**Sedimentation Comments on the Portland Harbor Draft Feasibility Study  
By Environmental Stewardship Concepts, LLC  
For the Willamette Riverkeeper and the Portland Harbor CAG  
July 27, 2012**

## Portland Harbor Draft Feasibility Study Comments Related to Sedimentation

Figure 1. Annual Peak Streamflow

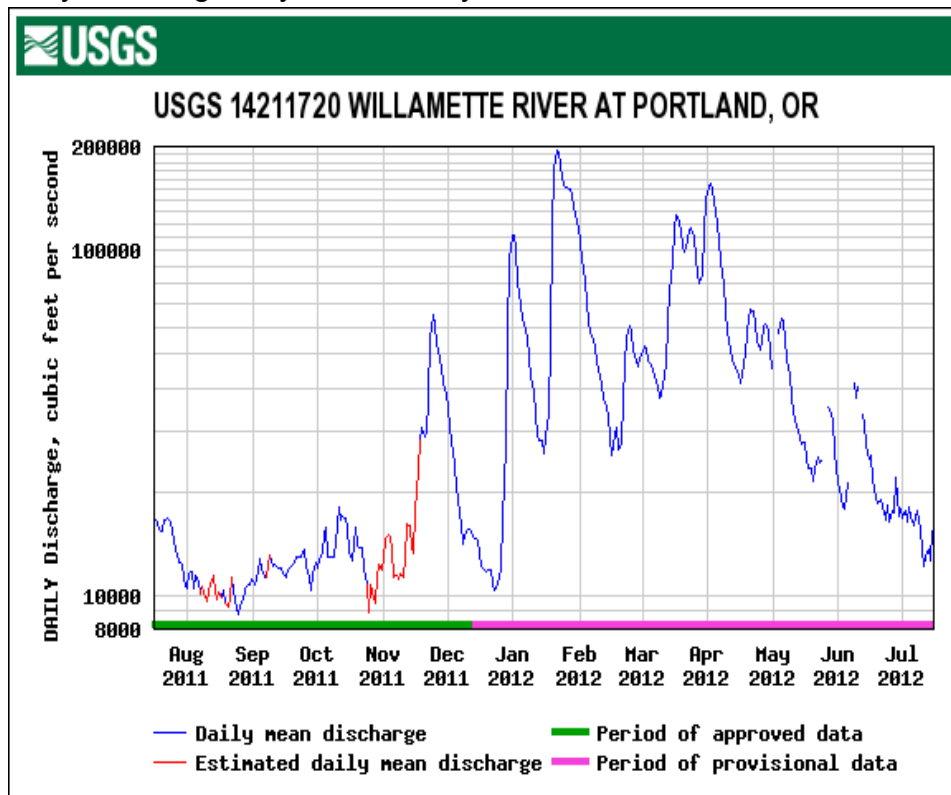
Figure 1 shows the highest streamflow recorded for each year, from 1972 to 2011, at Portland Harbor. Figure 2 shows the daily discharge, or streamflow, for one continuous year at Portland Harbor (July 2011-July 2012). These figures demonstrate the high flow capabilities of the river at Portland Harbor. As streamflow increases, the less likely the sediment will be able to drop out of the current and settle along the riverbed.
